**2 Meadow Road,
Ashmole Estate,
Lambeth, London,
SW8 1QB**

S73 application for minor changes
to Approved scheme 19/00744/FUL
and additional units

Oct 2025

Ground Floor Plan Revision

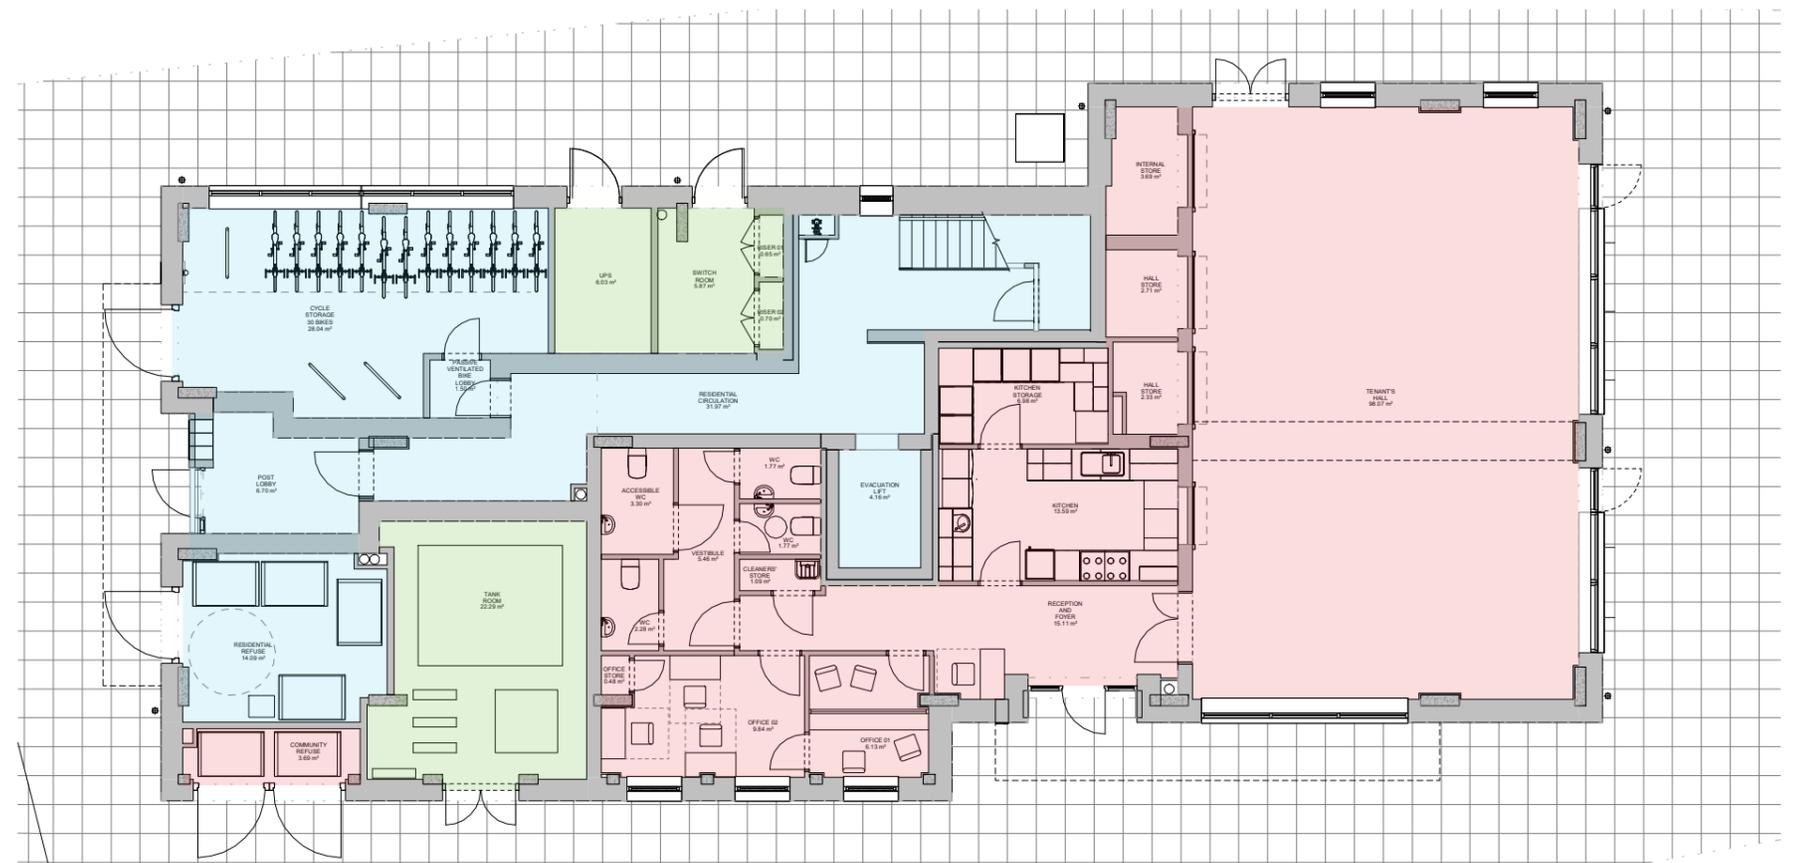
- Undersized Plant Room / no evident sprinkler tank
- No smoke vents for Evacuation Lift Lobby
- Resident Refuse Store on north of building requires second exit from stairwell that is a security risk, and requires refuse lorry to pull up in front of Wisden House to the north
- Tenants Hall over 100m² would require commercial fire suppression system with separate sprinkler tank of approx 13000 litre capacity 2m x 3.5m x 2m
- Cycle store opening directly into lobby would not meet Fire Service requirements
- No postboxes or post lobby shown

- Minor repositioning of building
- Retains similar location of entrances
- Increases sizes of plant room to include UPS for evacuation lift, switch room and sprinkler tank room
- Cycle Store has lobby to corridor, cycle storage provision exceeds requirements and includes 25% Sheffield stands
- Tenants Hall office space revised (See page 15 : Tenants Hall Area Comparisons)
- Residential refuse store adjacent to front door is more convenient for residents and for refuse pickup
- Residential lobby meets space requirements, fire safety regulations
- Post Lobby included for residential entrance, lobby to bike store as required for Fire Strategy
- Rainwater pipes moved to north of building to minimise drainage impact on mature tree roots to the south of the building

First to Third Floor Plan Approved

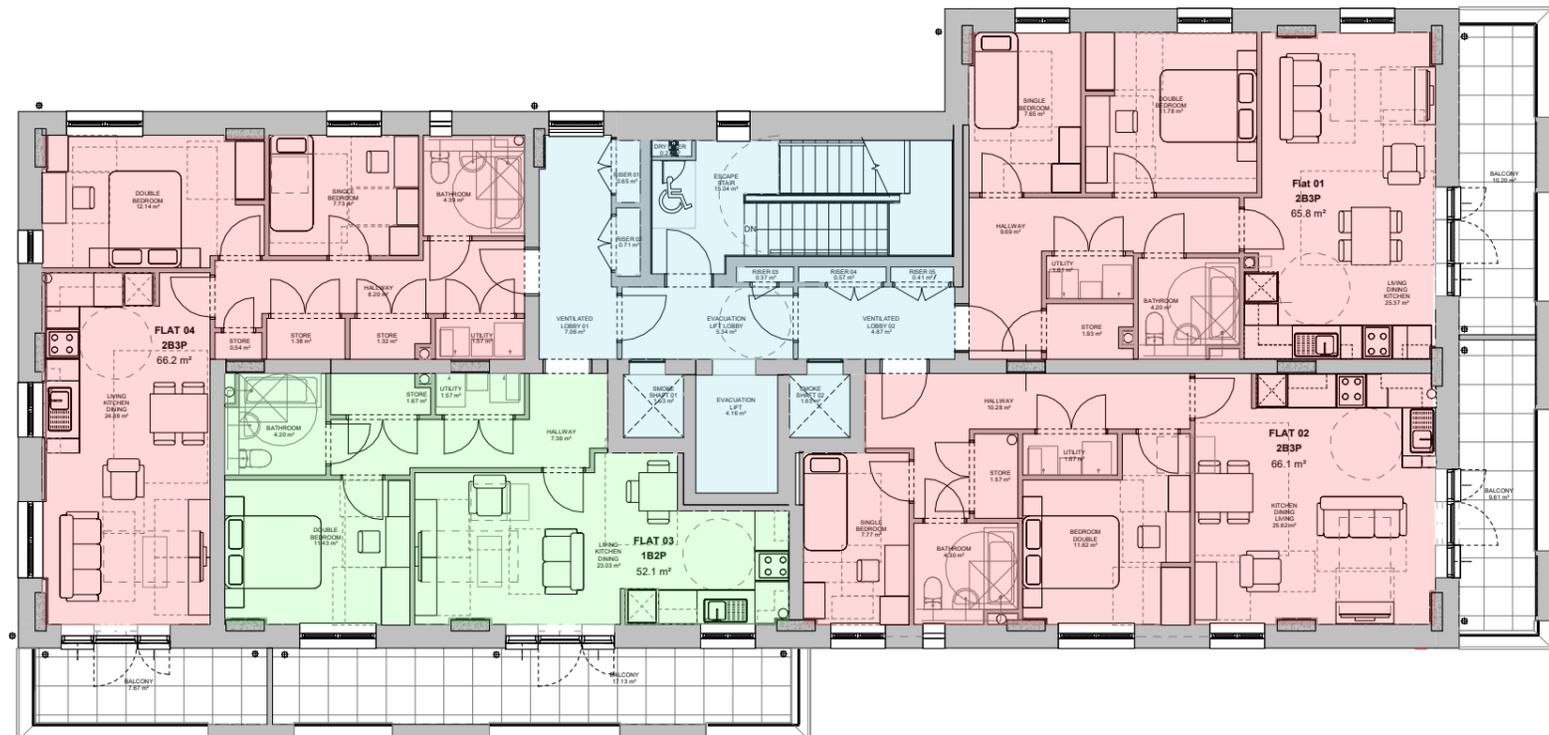
- Lobby design was compliant at time of approval but has now become non-compliant due to building regulation changes.
- No utility cupboards in flats to contain distribution boards, heating and ventilation equipment for new Air Source Heat Pumps
- Three flats are dual aspect, one is single aspect

- Evacuation Lift with UPS provided as required
- Smoke shafts to ventilate lobbies between lift and flat entrances
- Natural light available into common hallway
- Flat layouts now require utility cupboard in addition to storage space
- Three flats are dual aspect, one is single aspect

Fifth Floor Plan Revision

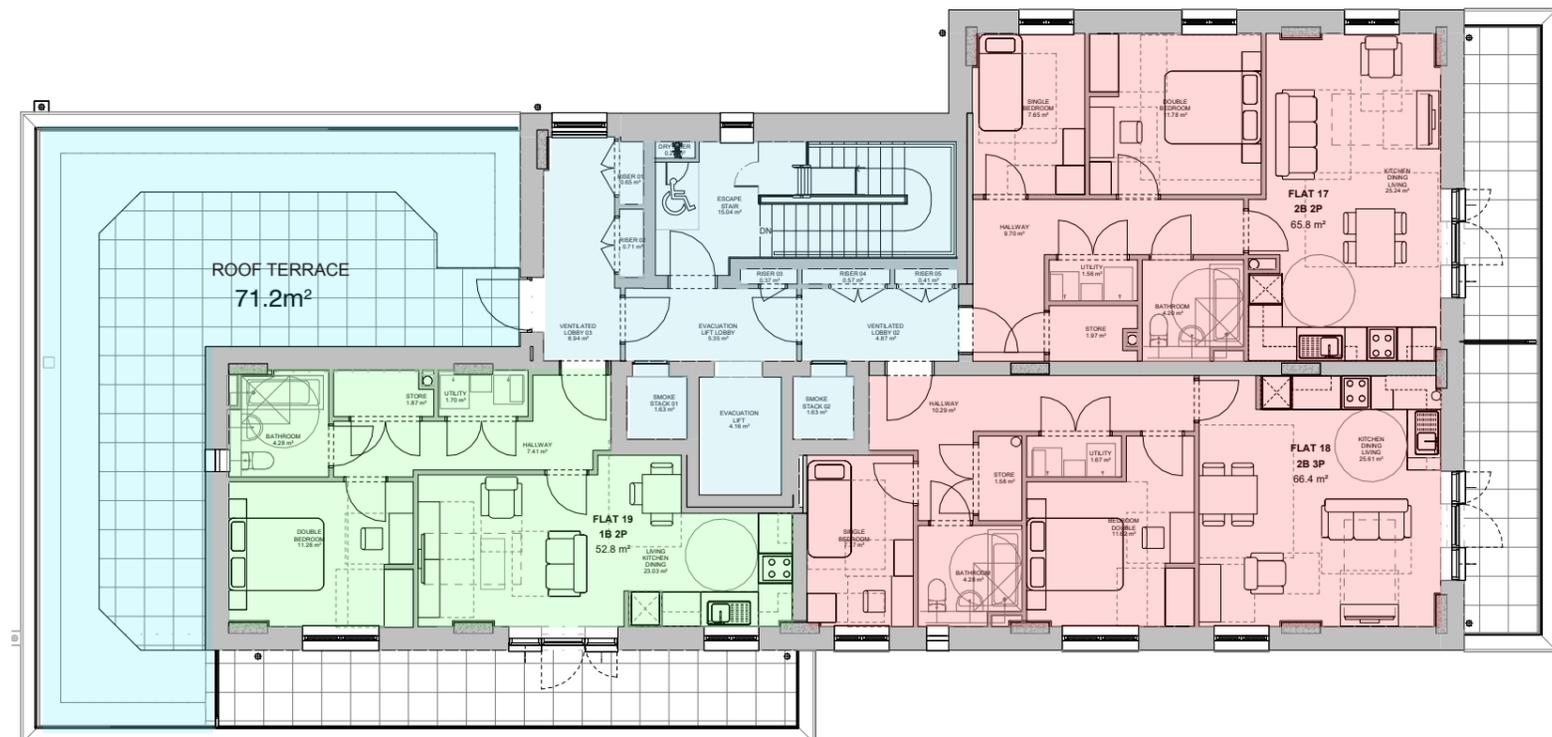
- Introduces a set back at the west end of the building, with the a communal roof terrace replacing one of the two bed flats

- Setback at fourth floor increased to bring the mass of the fifth floor away from Wisden House
- Enlarged communal roof terrace to 71.2m².
- Planting on perimeter of roof terrace serves to minimise overlooking of Wisden House - more detail on page 33

Roof Plan Revision

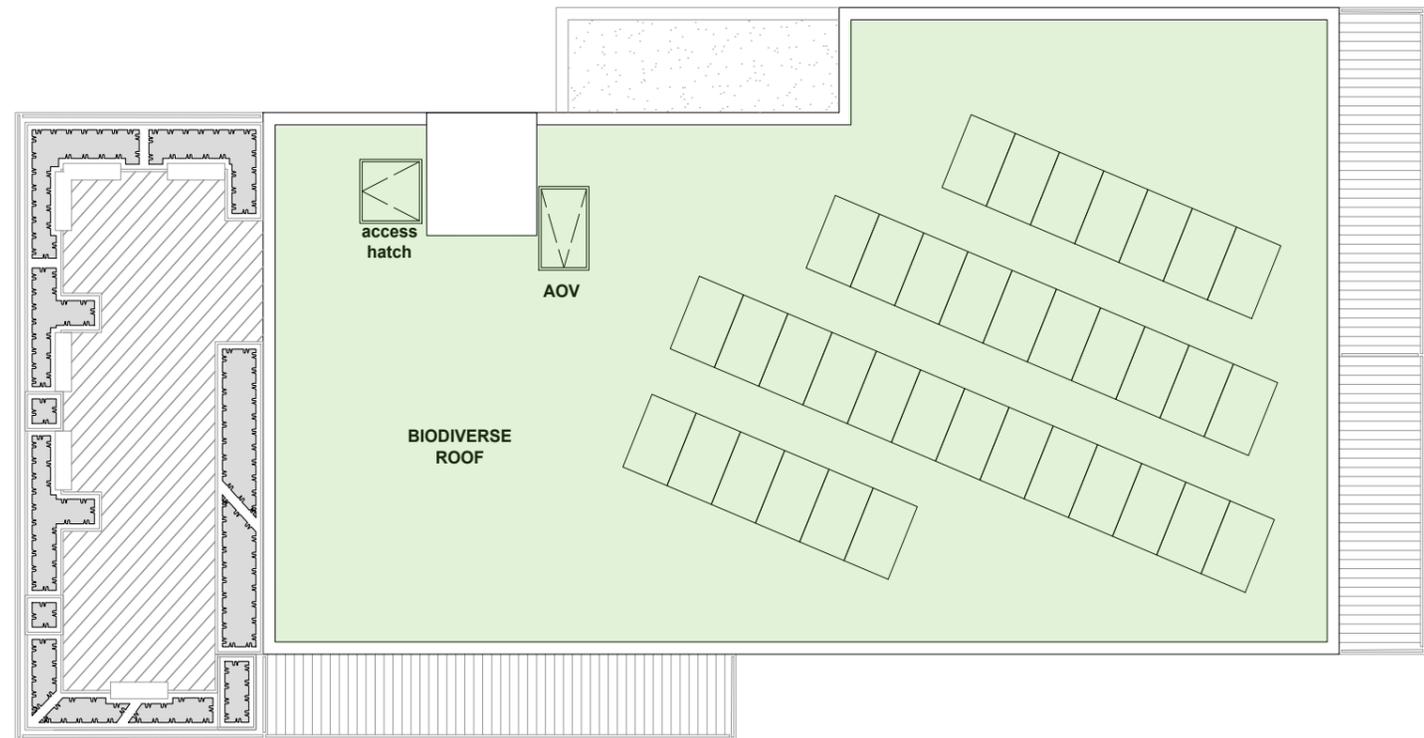
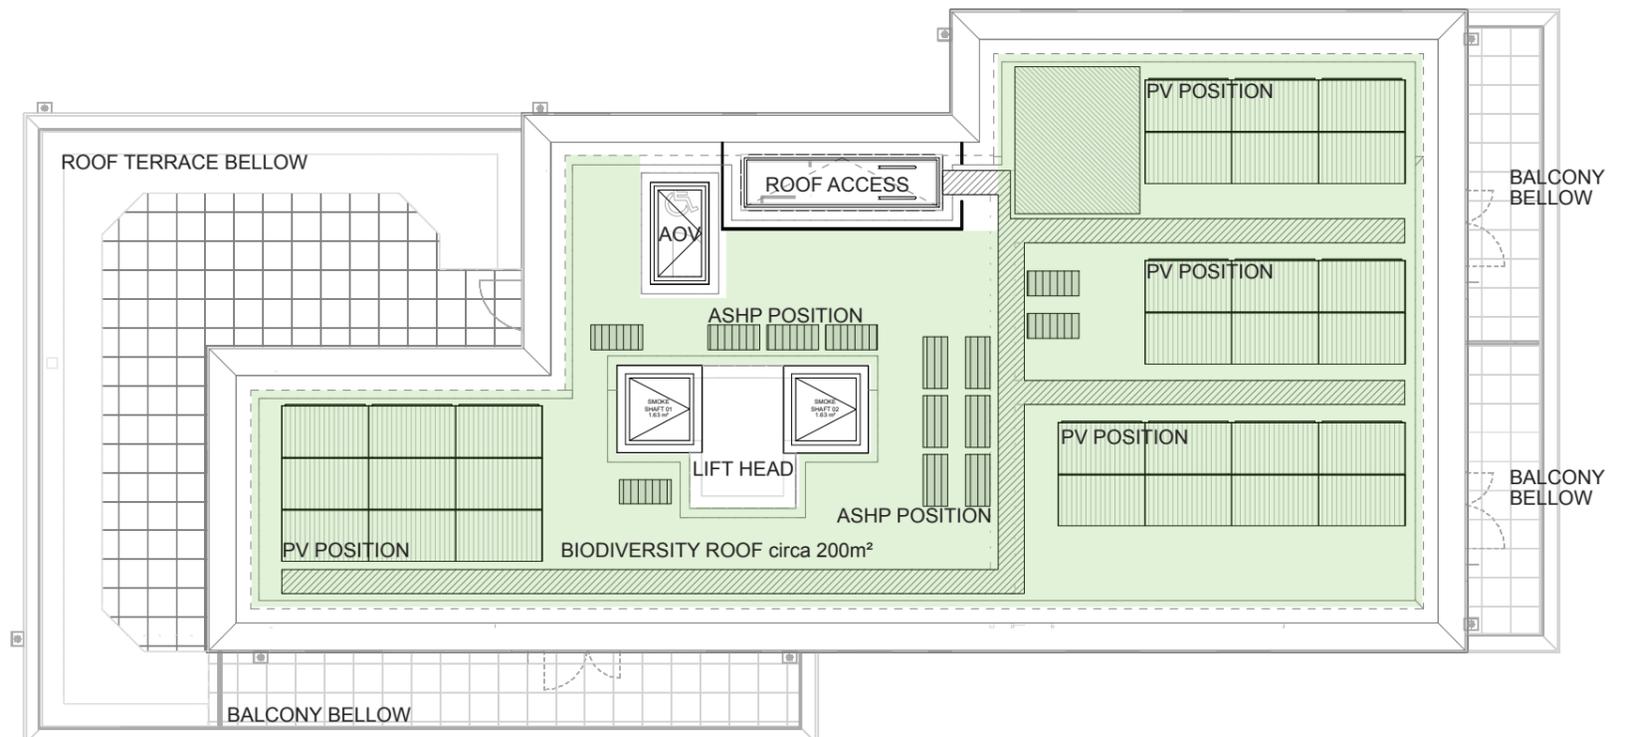
- Top roof only accessible for maintenance of Photovoltaic Panels
- Upper roof area approx 200m² biodiverse roof
- Access to roof via ladder
- Lift over-run location increases impact on Wisden House

- Top roof only accessible for maintenance of Photovoltaic Panels and ASHP Condensers.
- Upper roof area 215m² biodiverse roof
- Permanent Access stair to roof introduced
- Lift over-run located centrally reducing impact on Wisden House

South Elevation

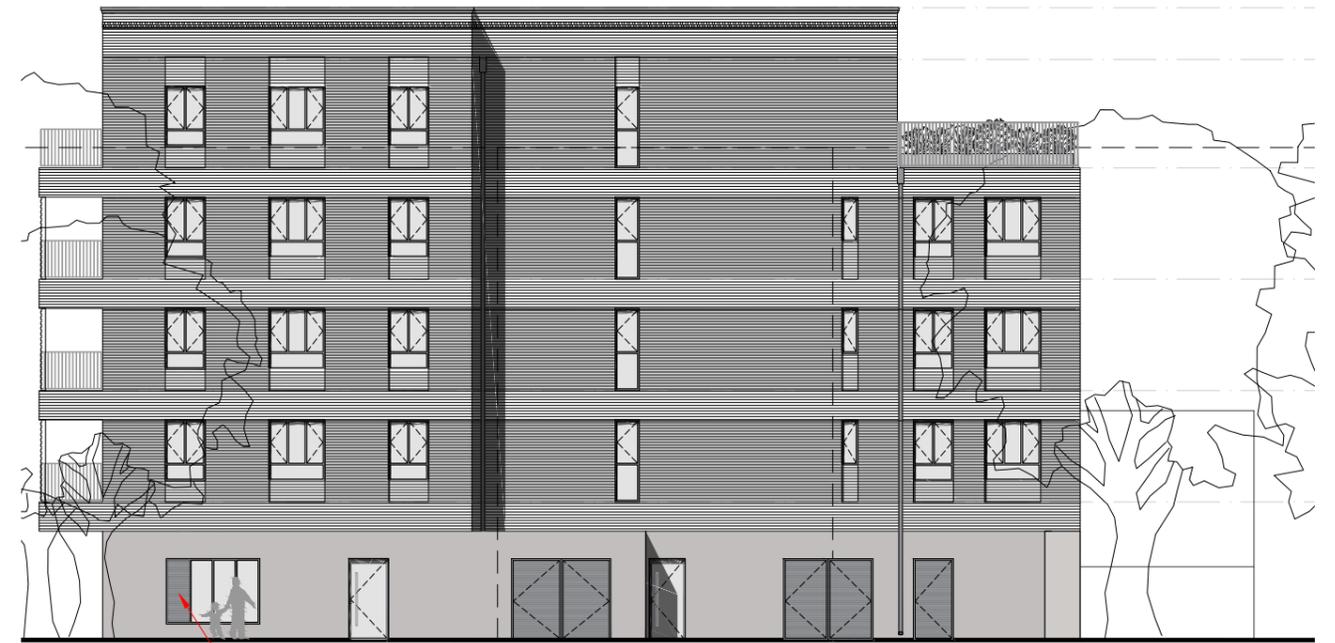
Five storey mixed use development with Tenant's Hall on ground floor and residential above. Material at ground floor is precast concrete panels, with brickwork above. Corbelled brick texture is used extensively on the elevations to create a banding effect. Residential units have enclosed brick balconies with brick panels. The choice of brick is covered on the Materials page of this report.

On the main public facing elevation the massing and fenestration patterns are very closely matched to the approved scheme, but have minor differences to match changes in flat layouts internally. A metal clad canopy has been provided above the door of the Tenants' Hall.

The ground floor is no longer clad in concrete, but instead in a brick with a darker colour than the upper floors to create visual separation between the ground and upper floors. A corbelled brick pattern is used to create texture and movement on the elevation, in strategically placed areas in order to provide interest and visual variety

Tenants Hall Area Comparisons

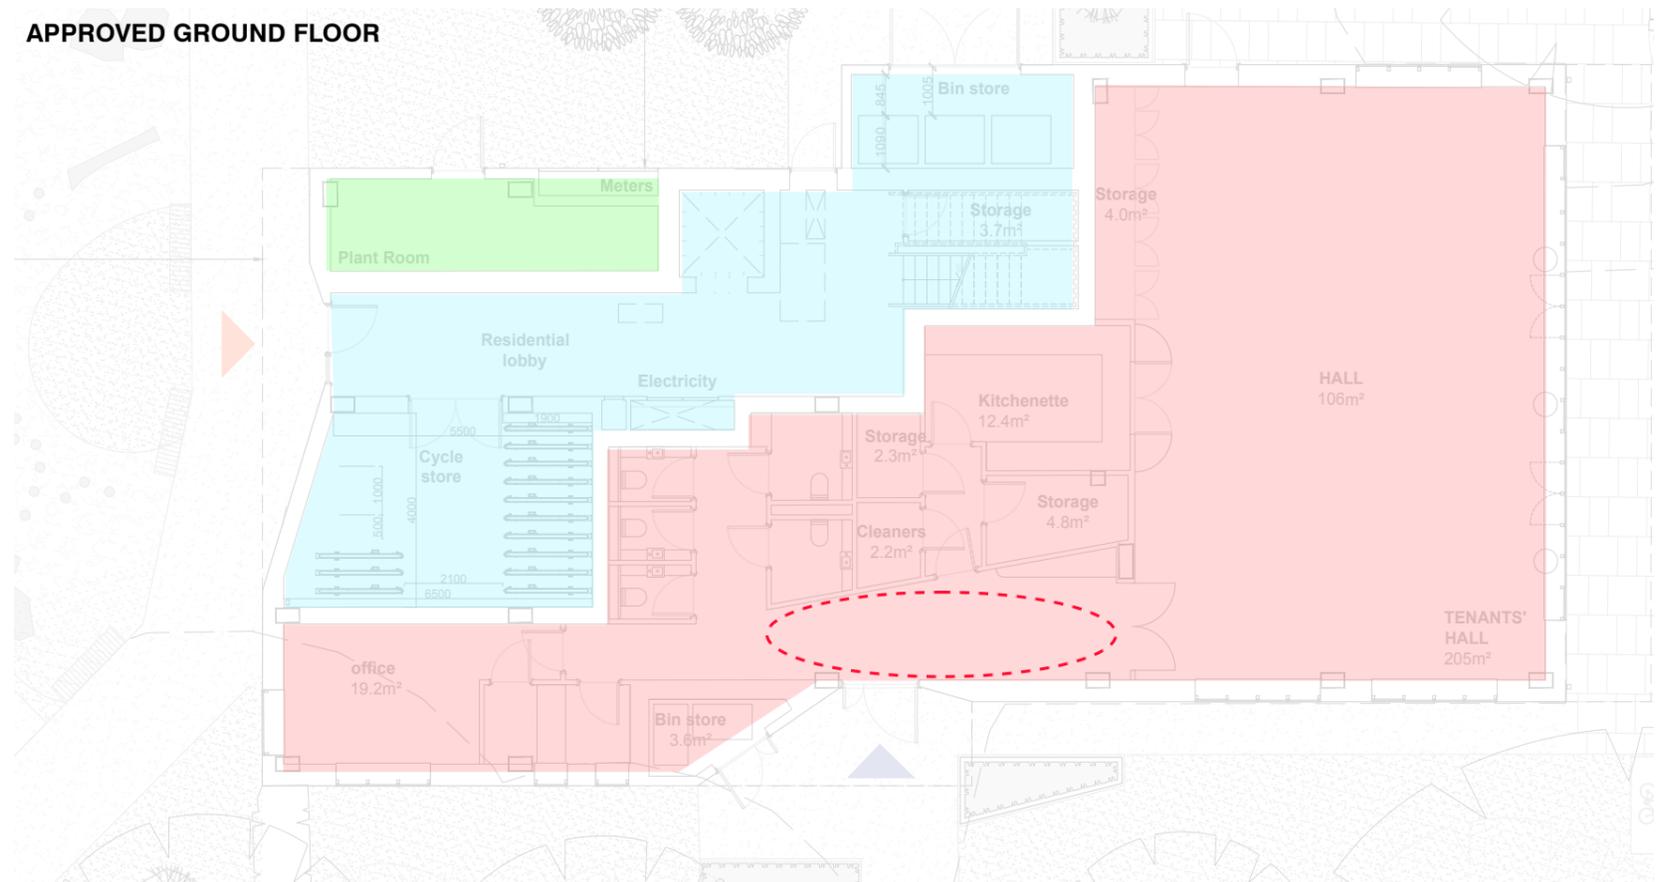
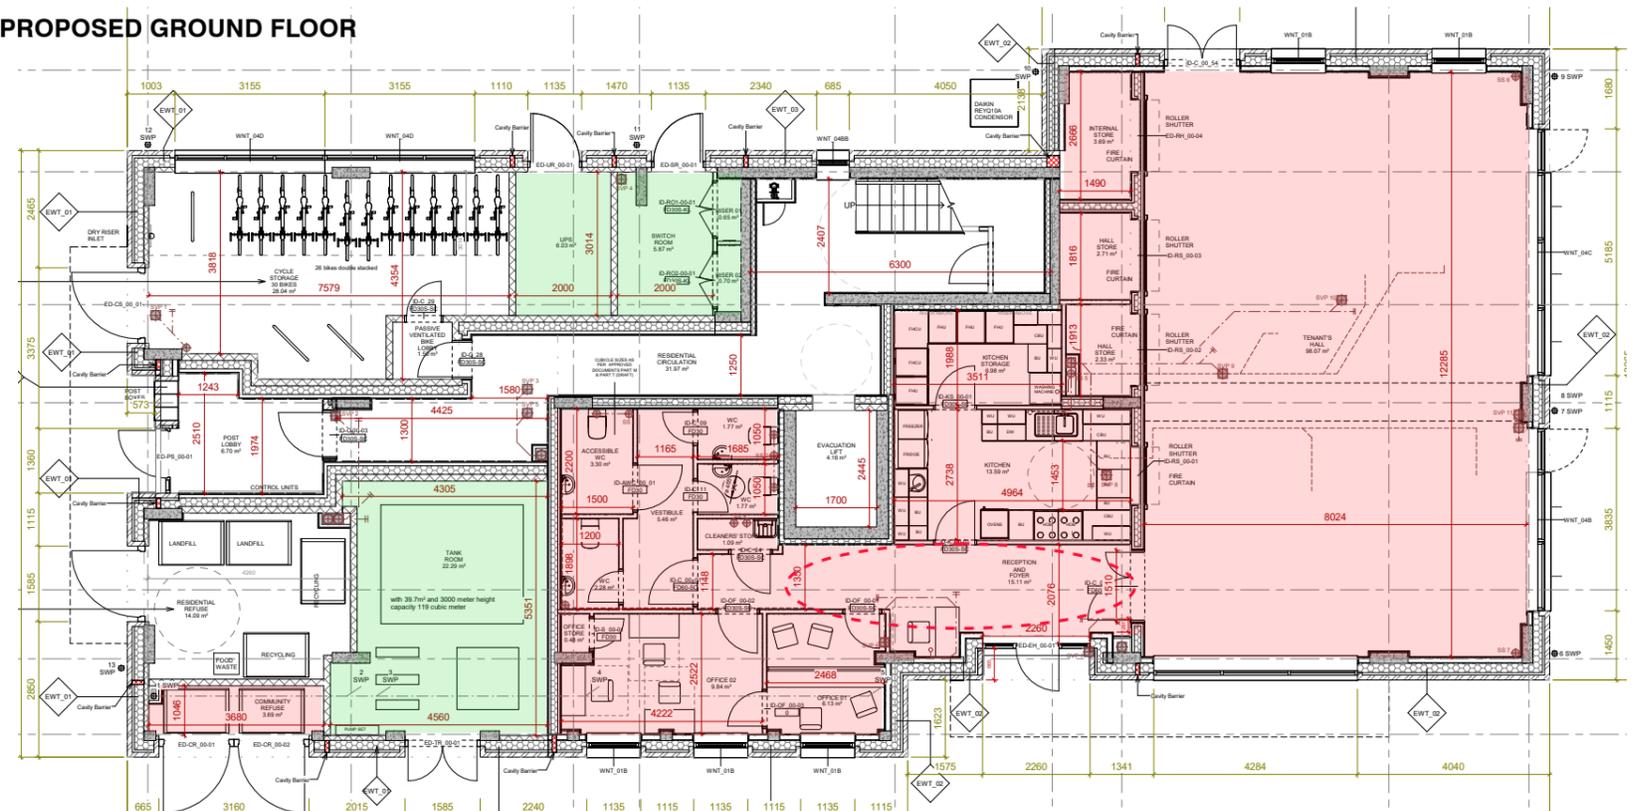
The pre-app meeting of 02/06/2025 for Meadow Road showed a slight reduction in the area of the Tenants Hall, There was concern expressed that this would result in a reduced quality of facility for the tenants. The chart below shows a comparison between the areas provided in the approved scheme and the proposed scheme.

The hall itself has to be under 100m² in order to allow the Tenants spaces to be served by the residential sprinkler system. The 2021 London Plan Policy D12 requires Fire Suppression in buildings over 11m. A hall larger than 100m² would require a commercial sprinkler installation with a very large water tank which would have a massive impact on the building layout. This accounts for approximately one third of the reduced areas.

The majority of the remaining reduction is in circulation space, in the WCs and in the hallway. This reduction should not negatively impact the facilities

It is worth noting that the proposed ground floor plans show a more accurate size for residential cycle storage, refuse stores and plant rooms than the approved scheme, and some of the Tenants Hall area 'lost' has gone to the proper sizing of the Switch room, Lift, UPS room and Sprinkler Tank room.
